**HOST PARK FENCE REPLACEMENT
eRFQ-24-03-NELHA / HIePRO Q25001314
ADDENDUM 1**

Exhibit E3: Sleeve Method of Post Installation

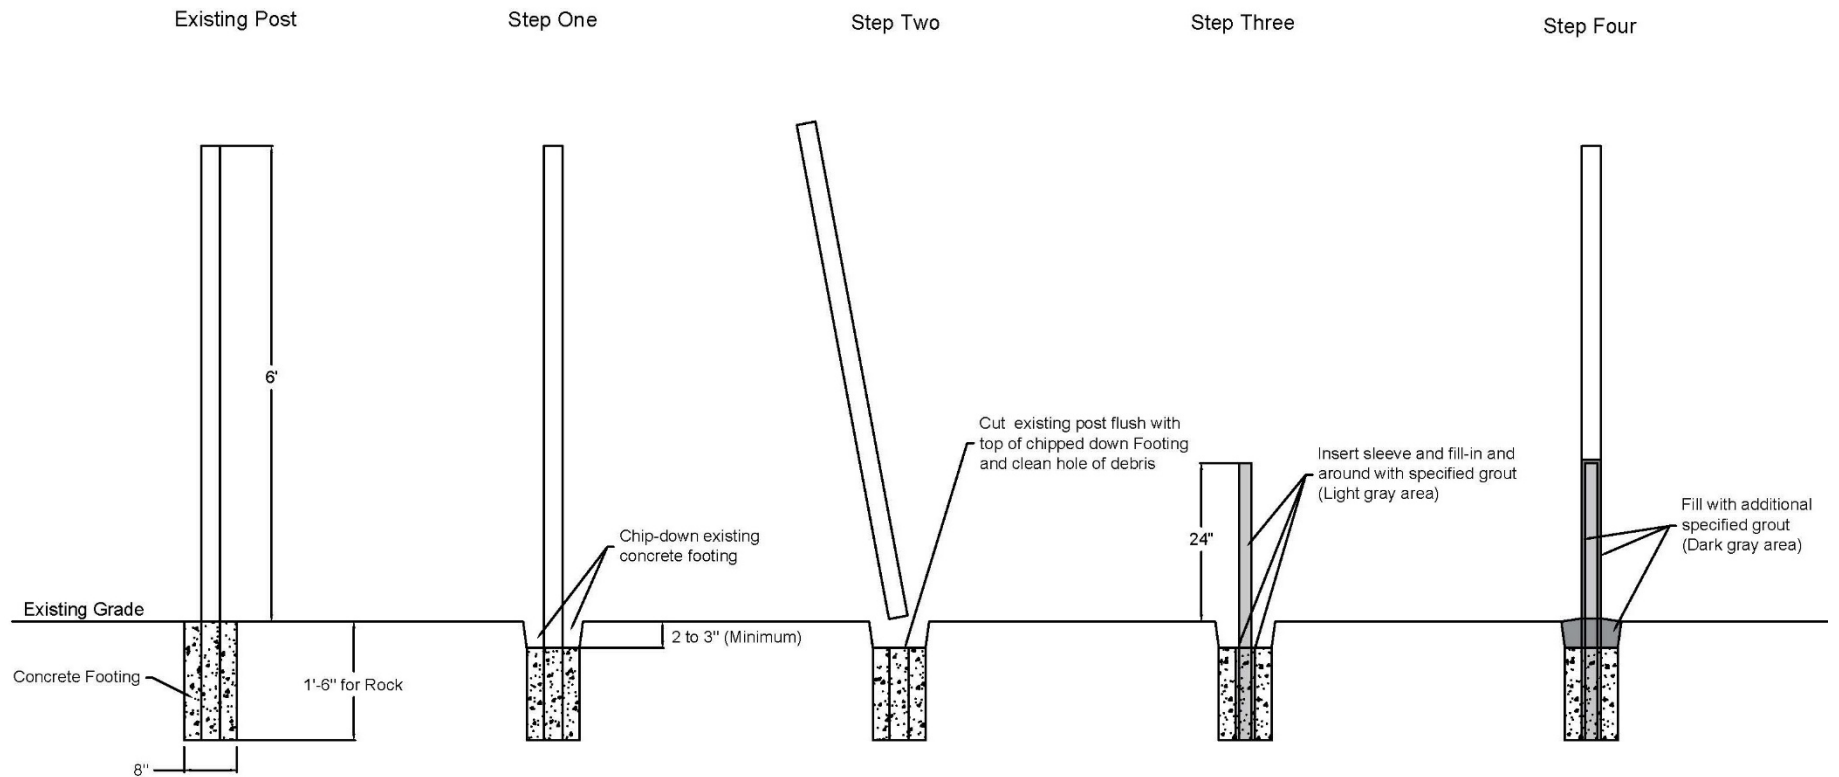
The purpose of Addendum 1 is to revise Exhibit E3: Sleeve Method of Fence Post Installation. Sleeve diameter has been decreased for 2-3/8" line posts and a 2-7/8" line posts. In addition, the Sleeve Size Table will also include a sleeve size for a 1-7/8" existing line post. Refer to the revised Exhibit E3 below:

Post Type	Existing Post Diameter (in)	Sleeve Diameter (in)
Line	1-7/8	#8 Grade 60 Rebar
Line	2-3/8	1-5/8
Terminal / Corner	2-7/8	1-7/8
Gate	4	2-7/8
